TRANSPORT ASSESSMENT & TRAVEL PLAN ADDENDUM

Viadux Phase 2 Minor Material Amendment

VN201568

Transport Statement and Framework Travel Plan Addendum

DRAWING NUMBER:	VD21525-D137	REVISION:	P02
-----------------	--------------	-----------	-----

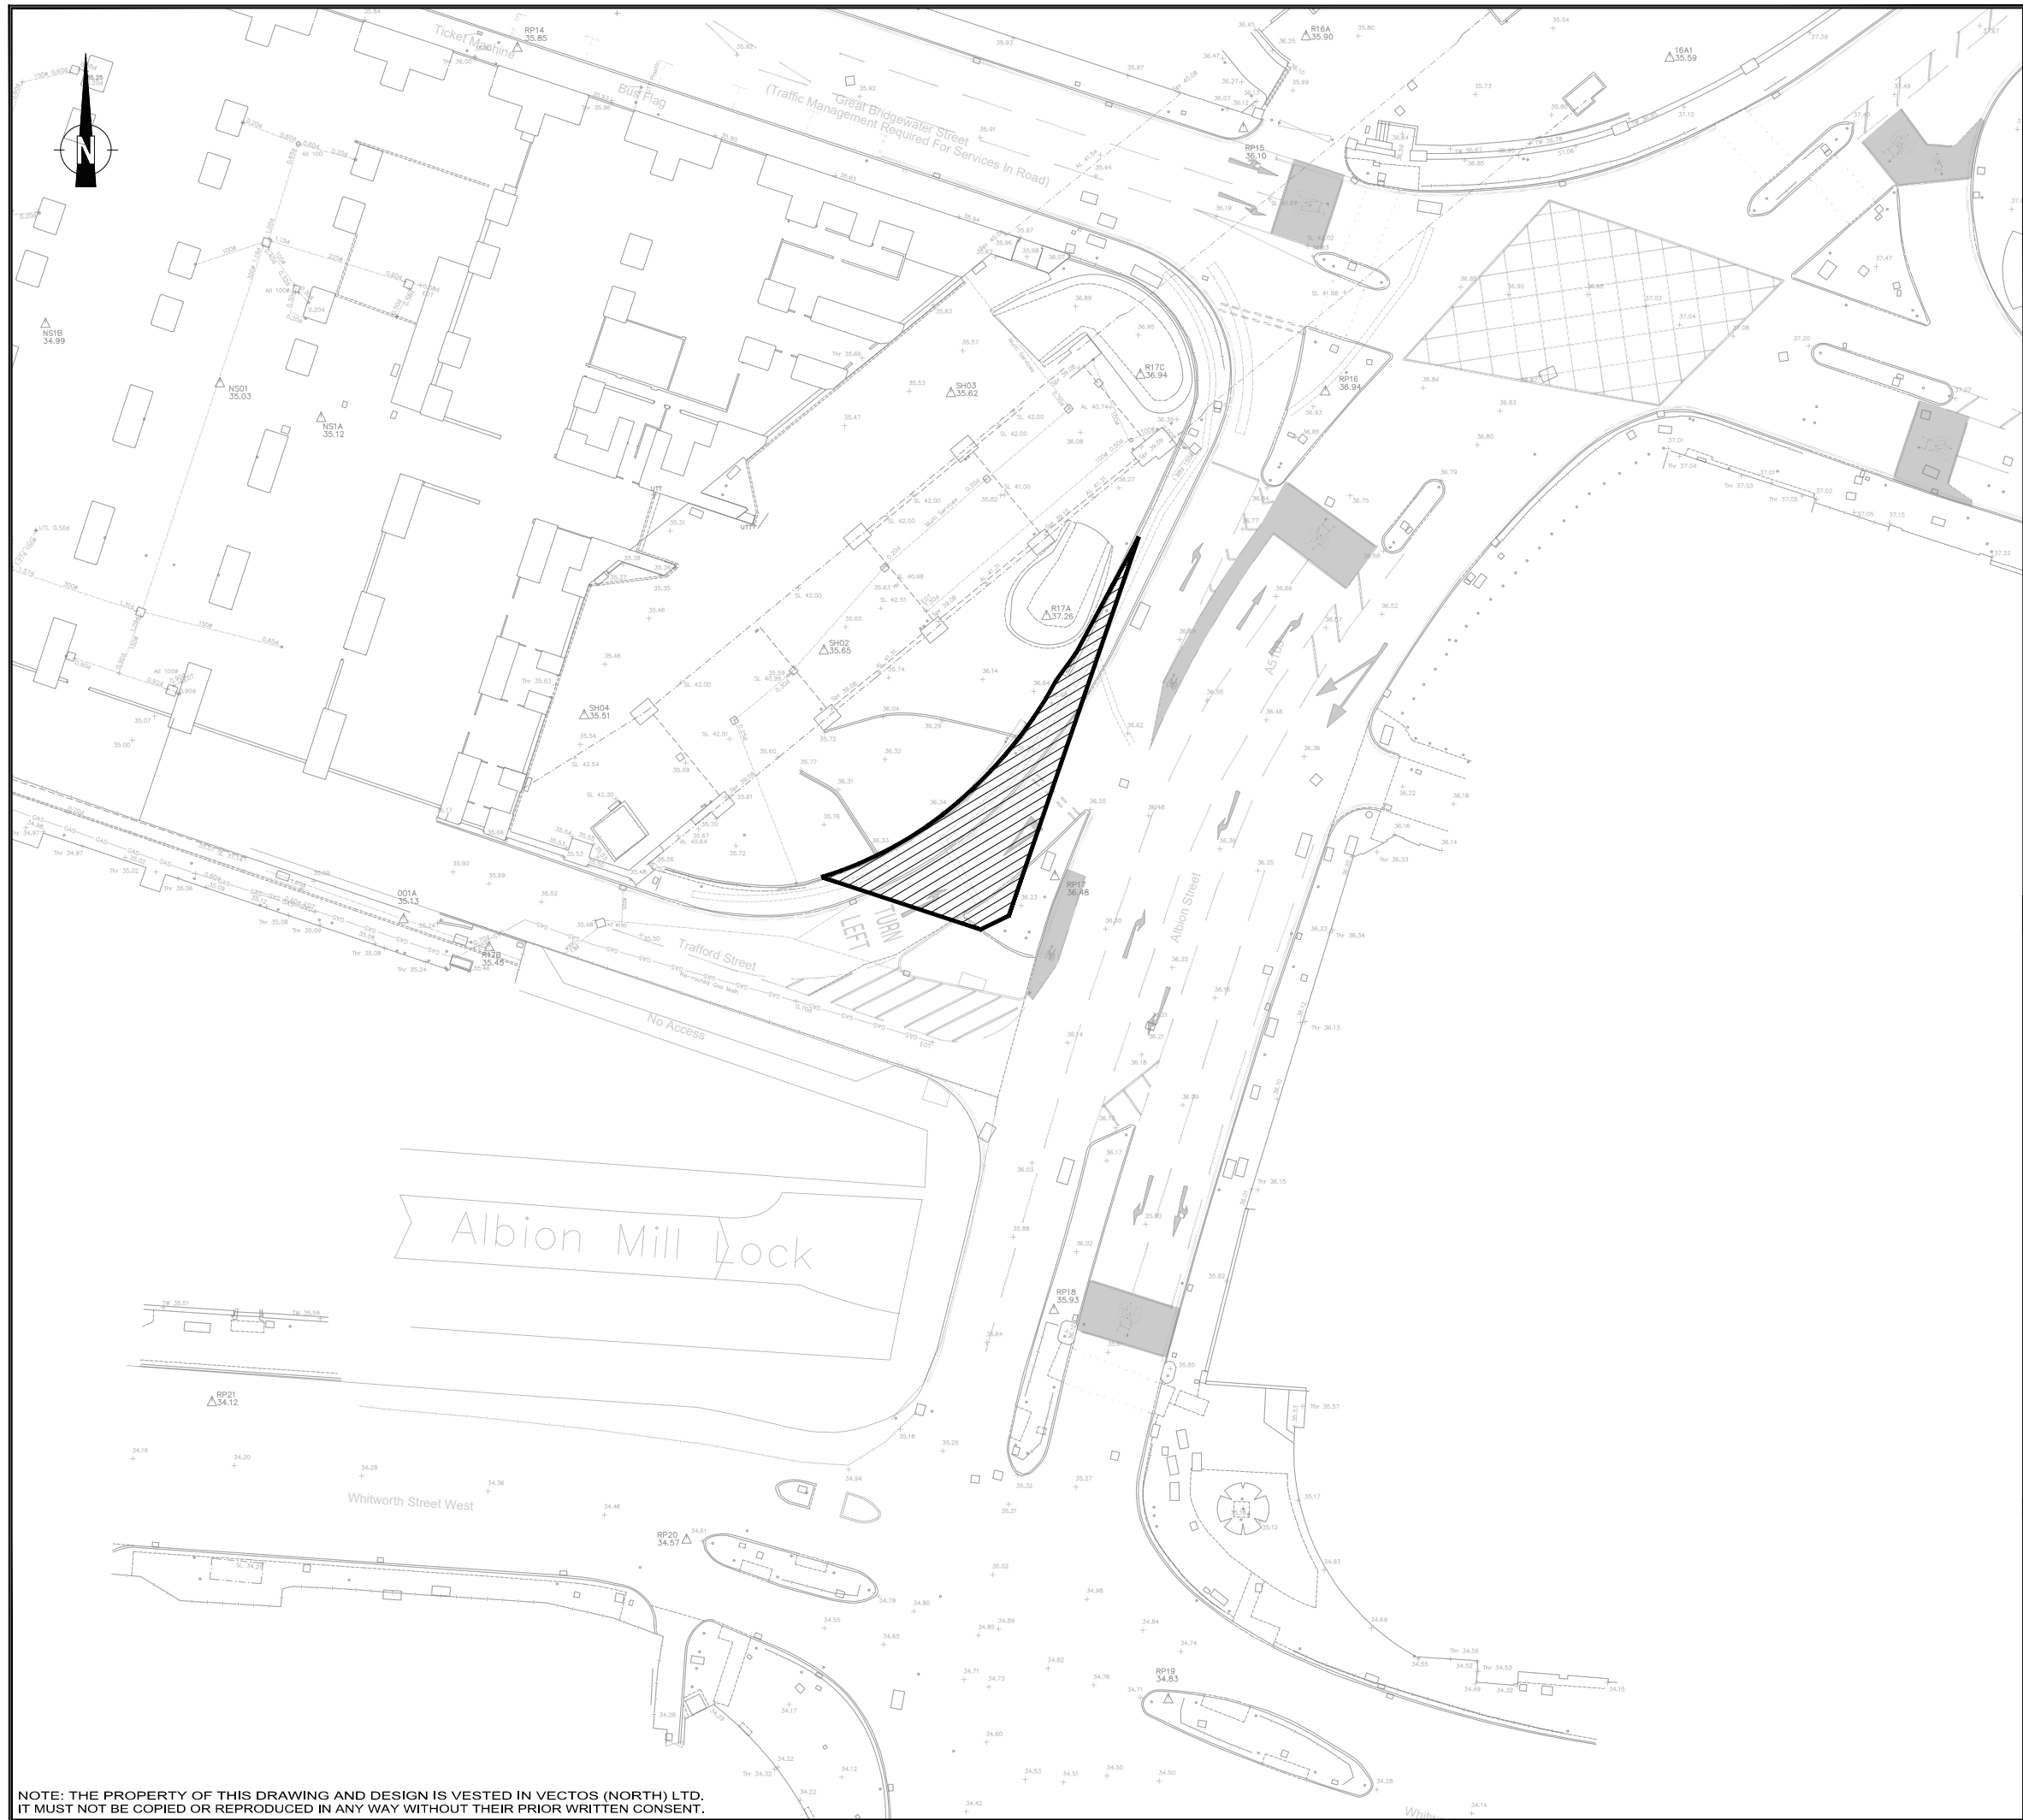
- 2.18 The construction of the office building will partly be on the existing highway. Where that occurs, the highway will be stopped up and with this MMA the area to be stopped up is similar to that as described in the approved plans with some minor changes arising from the position of steps on the highway. The extent of the area to be stopped up is shown in **Dwg VD21525-D137 P02**.
- 2.19 Manchester City Council have been appointed to progress the Stopping Up Order.

PROPOSED ENTRANCE

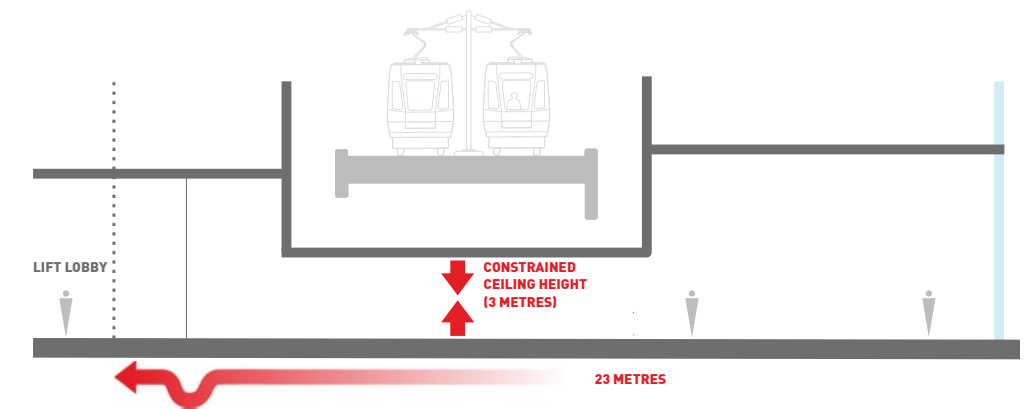
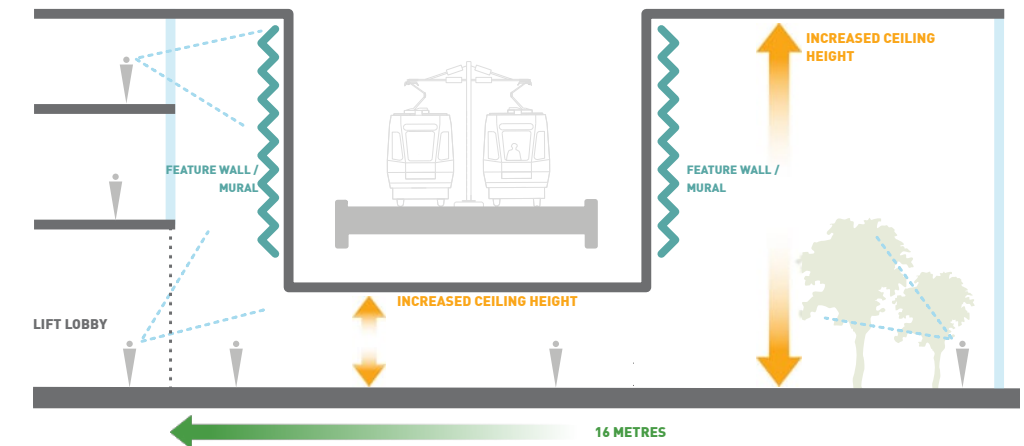
B - The office entrance has been moved further down Albion Street to remove internal level changes and increase the headroom available underneath the tram bridge.

- Simplified geometry feels a more appropriate response
- Belongs to the orthogonal language of the pavilion
- Forms a strong corner
- Addresses Albion street and has clear visibility

- Lack of sense of arrival
- Constrained headroom under metrolink

- Creates a sense of arrival
- Incorporates tram encapsulation as artwork / mural
- Releases the space for amenity

ADDITIONAL FLOOR OPTION

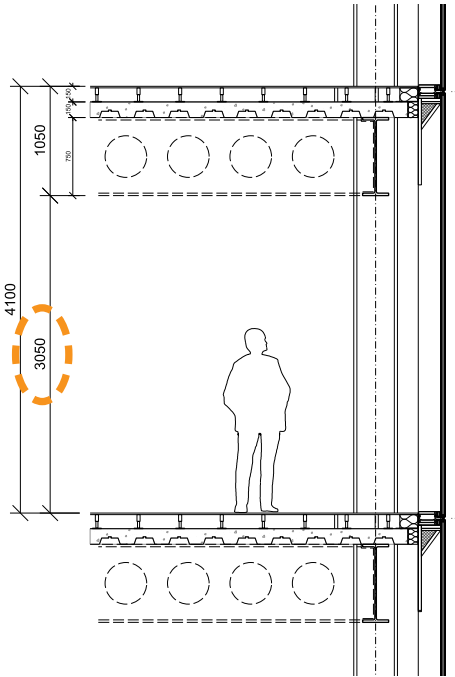
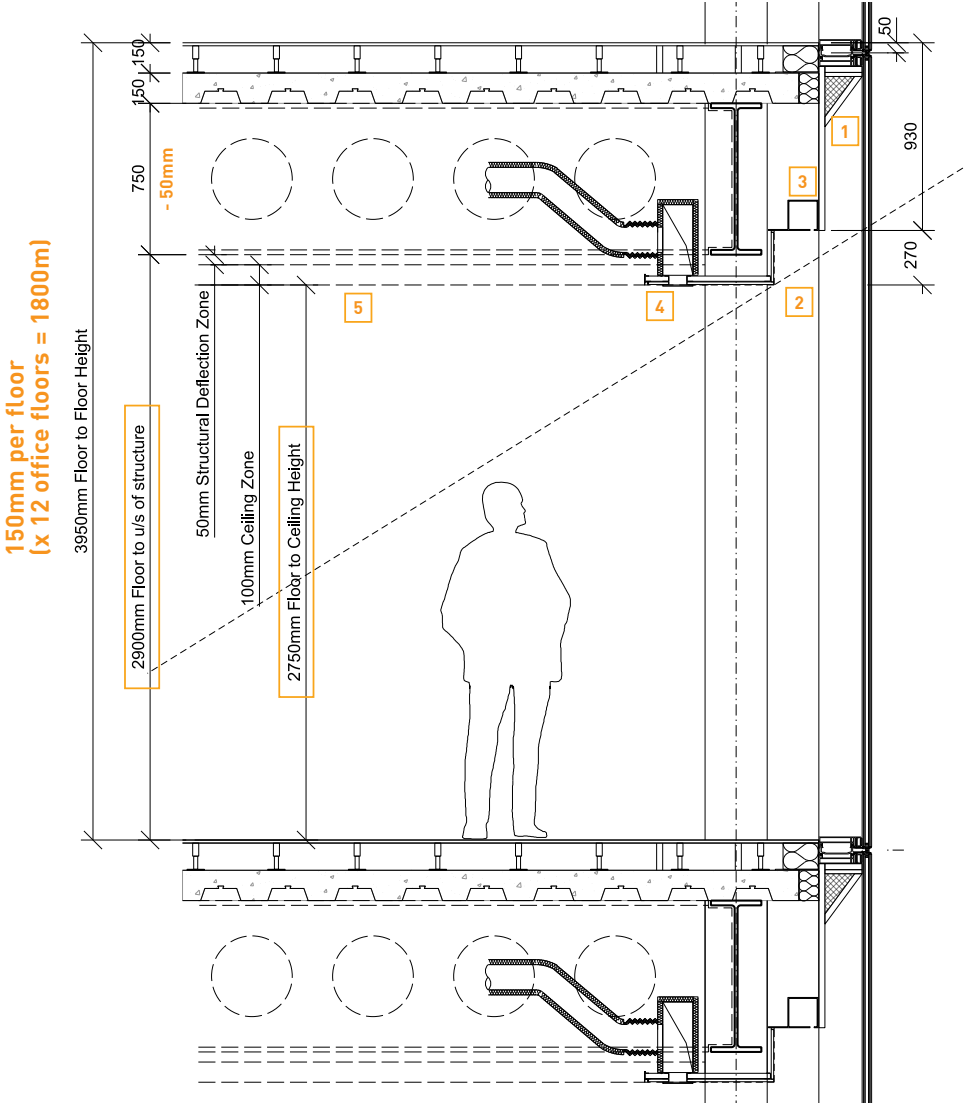
- A - The office floor to floor height has been revised following a review of the main structural beam depth and the client decision to have exposed soffits and services with no ceilings.
- As a result the floor to floor height has been revised from 4100mm to 3950mm with a 2900mm floor to underside of structure. (BCO Guide to Specification - Best practice for offices – 2019 recommends a clear height of 2.8 to 3.2m for spaces over 18m in depth).

- This provides a saving of 150mm per floor which equates to 1800mm over the 12 office floors.
- Further co-ordination of the distance required between the top of the Tram Encapsulation and the underside of the office level 02 structural slab also resulted in the need to raise the upper floors by 350mm. This ensures an adequate maintenace zone of 1200mm is maintained to allow for the inspection of the steelwork to the underside of level 02.
- B - The overall reduction in height of 1450mm (1800mm - 350mm) resulted in the decision to add a further office floor (3950mm) which results in an overall increase in height of 2500mm.

- The approved office building height is +108.300m AOD and the proposed office building height is +110.800m AOD.
- The additional floor offsets the omission of the pavilion building office floors, together with the provision of amenity space and green rooms to the main office floors.
- C - The overall office NIA has been increased by 12,110sqft (1,125sqm)
 - Approved NIA = 251,391sqft (23,355sqm)
 - Proposed NIA = 263,501sqft (24,480sqm)

NOTE:
150mm per floor (x 12 office floors = 1800m) - 350 = 1450mm
Additional floor +3950mm results in +2500mm increase in height

Consented Scheme

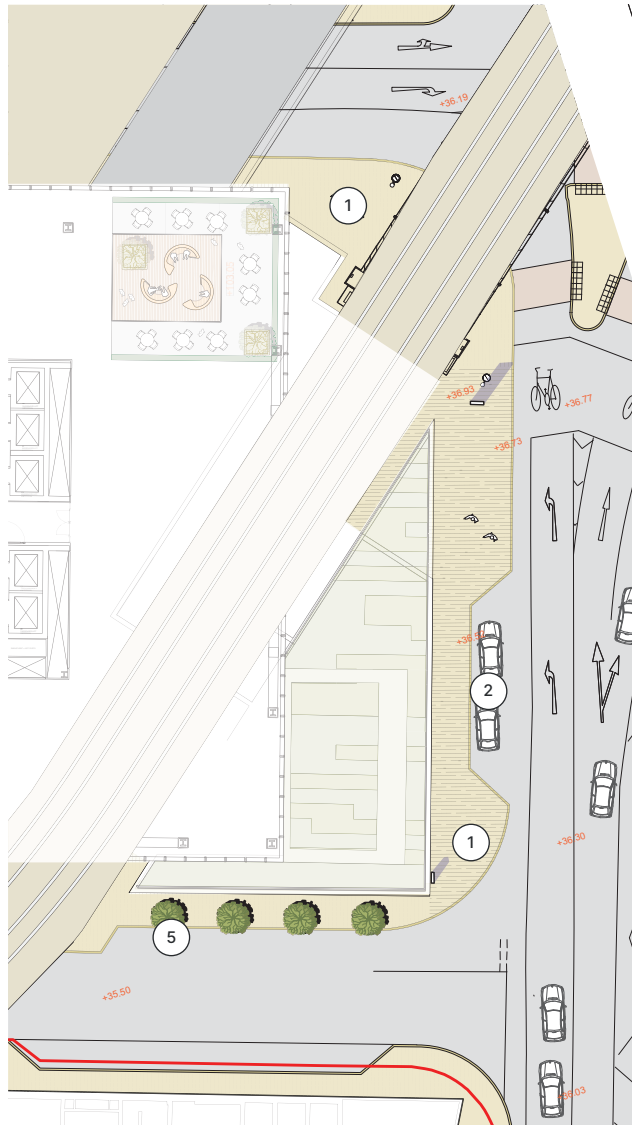
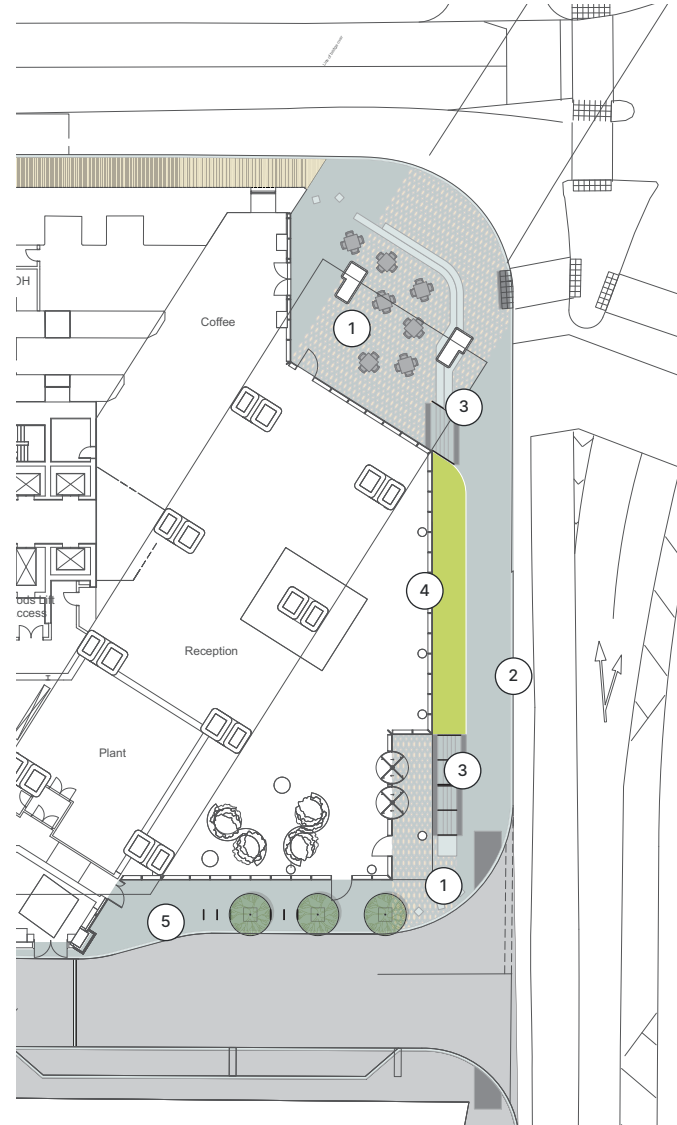
1. Paving materiality has been revised from yorkstone to granite with bespoke units.

Reason: To create a stronger sense of arrival, and acknowledgement of the heritage of the existing architectural features and heritage.

2. Omission of loading bay to Albion Street.

Reason: Servicing to be carried out from Trafford Street.

3. Introduction of steps and seating walls.

Reason: To accommodate level change around the site.

4. Introduction of soft landscaping along eastern building elevation.

Reason: To enhance amenity and biodiversity value in the public realm and to provide a visual connection with the green elements on the building above.

5. Omission of one tree to the south of the building.

Reason: Due to the tree pit clashing with existing services in the footway.
